Odyssey Health Club, Stevenage

Phase 1: New Entrance_ Proposed Roof Plan

Status: For Information	
Drawn by: LM	Date: October 2024
Checked by: MH	Date: October 2024
Scale: 1:100 @ A3	
Project no: 202112	
Drawing no: PL009	Rev: A

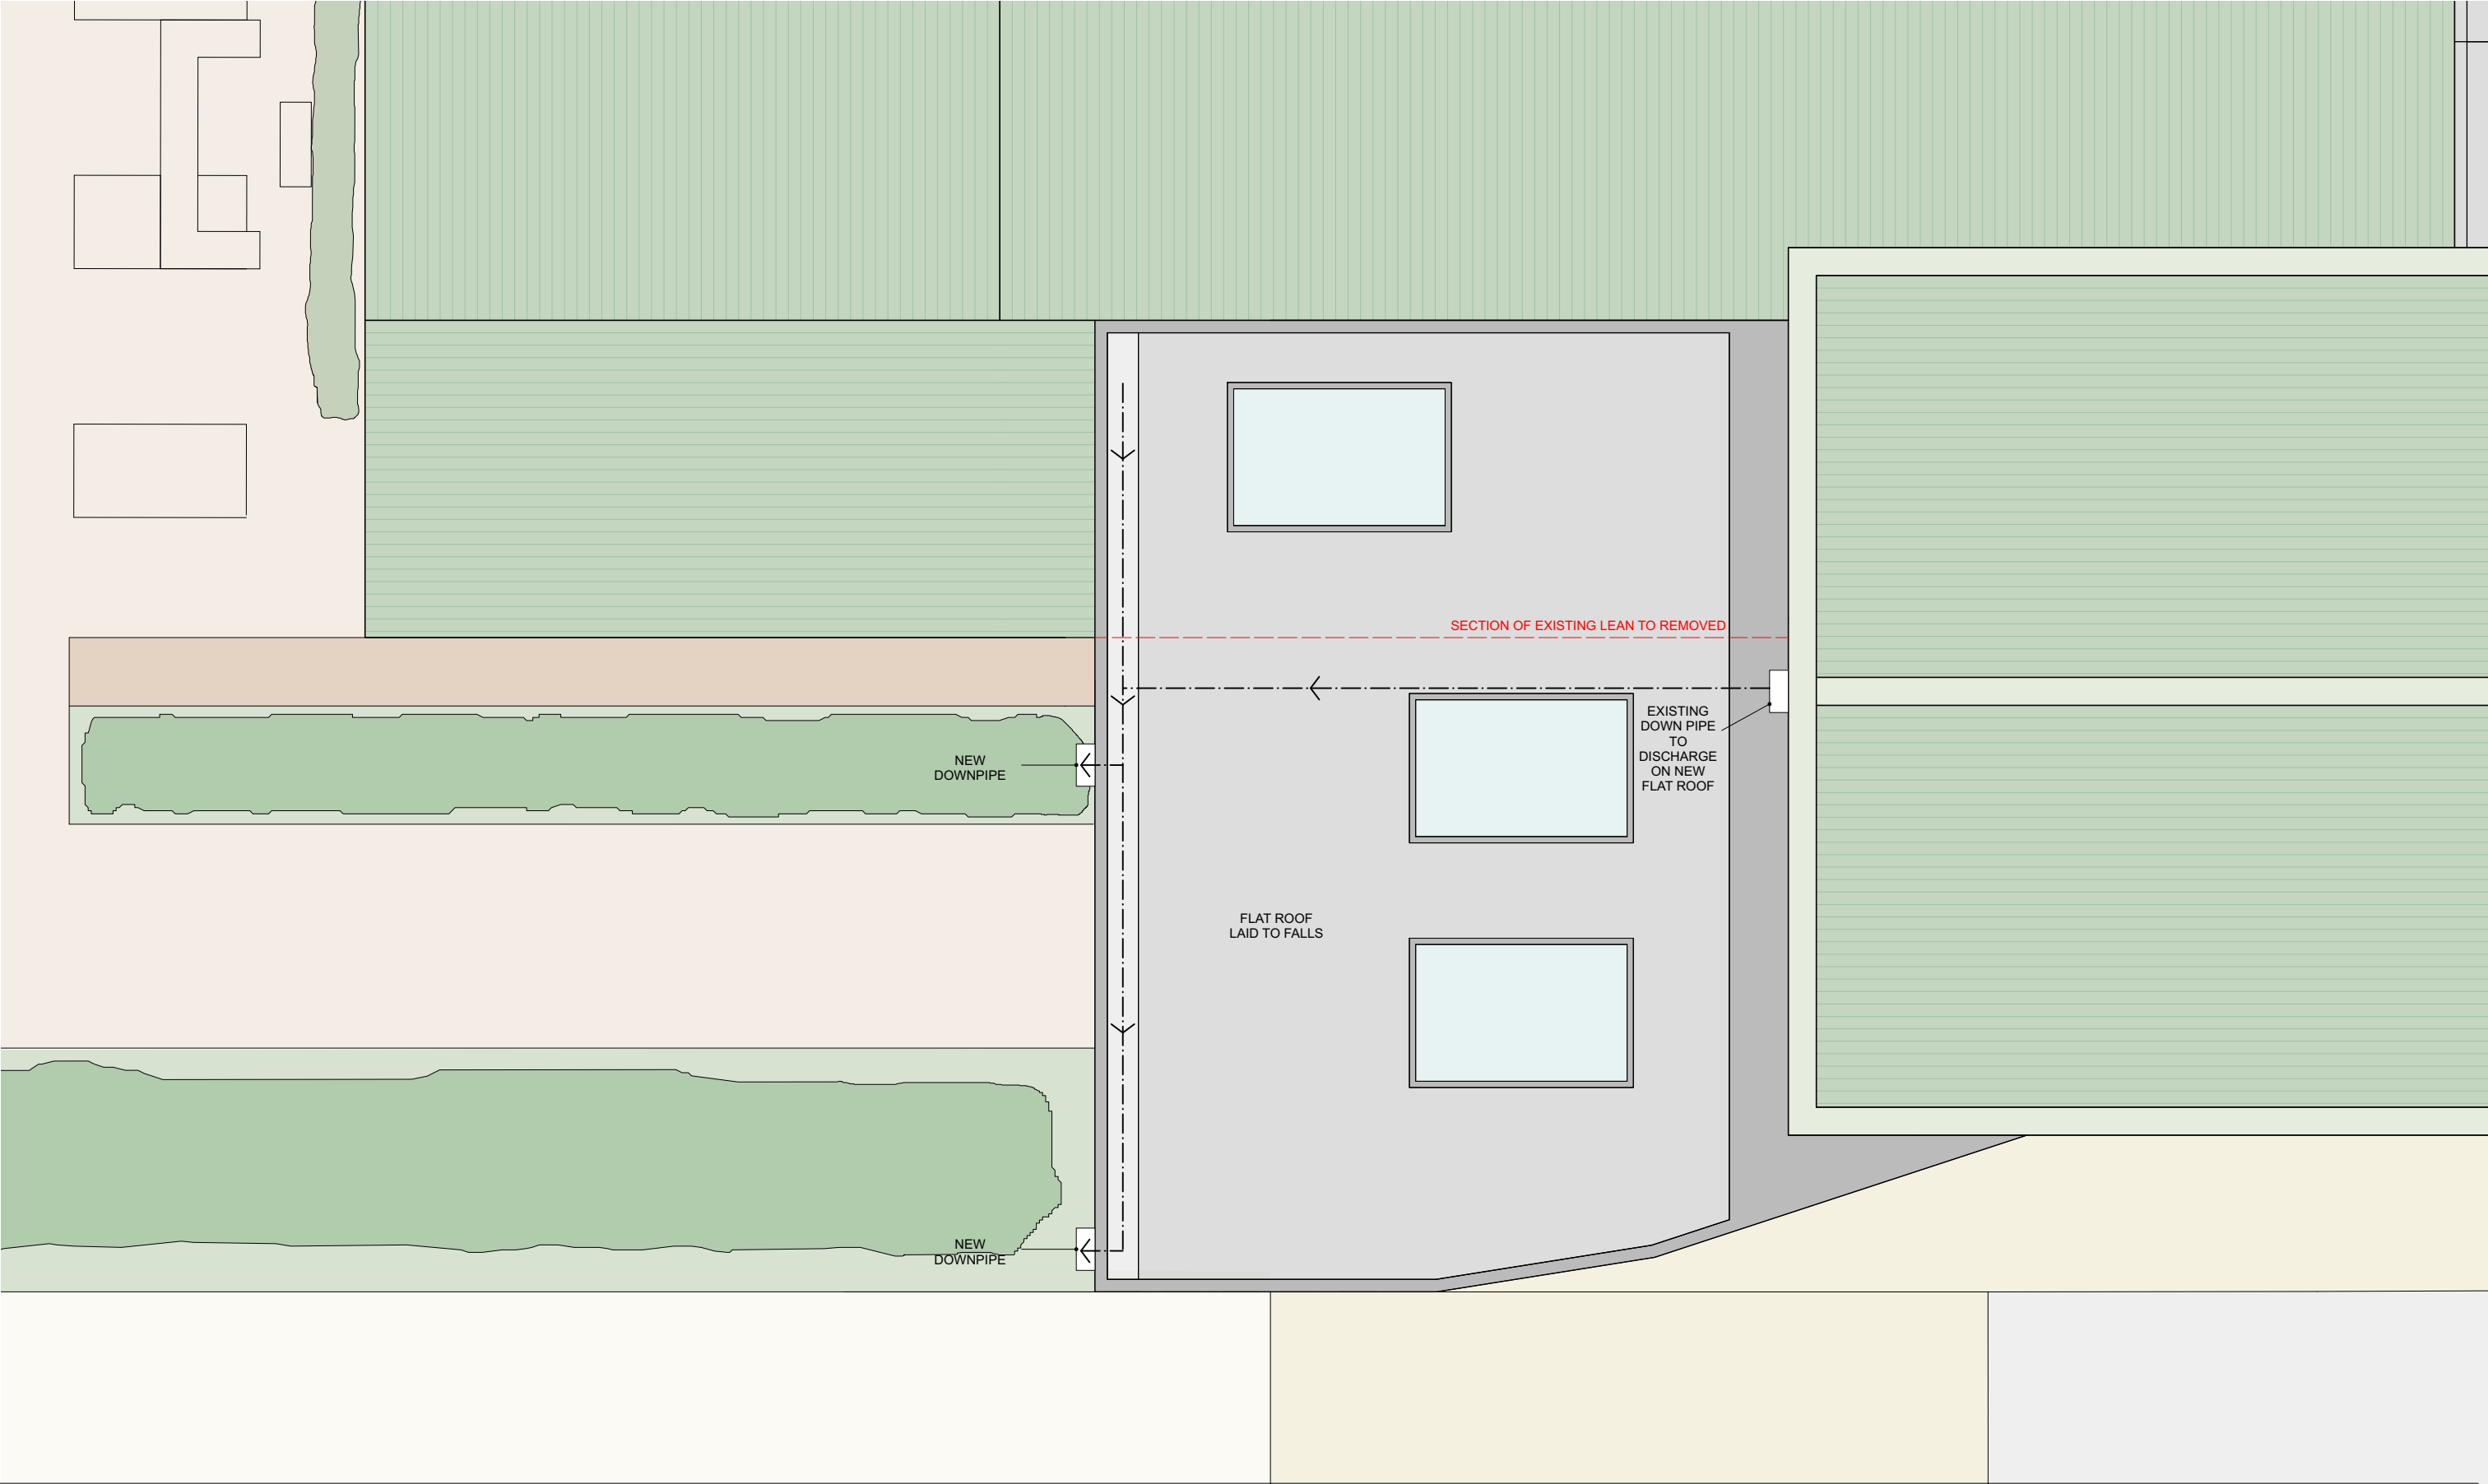
- Revisions:
- REV A: 15.10.2024**
- entrance design revised to suit installed sewer alignment
 - amendments made accordingly
 - hydrotherapy spa pool reduced in size
 - roof arrangement amended to suit steel frame, section of existing lean-to removed
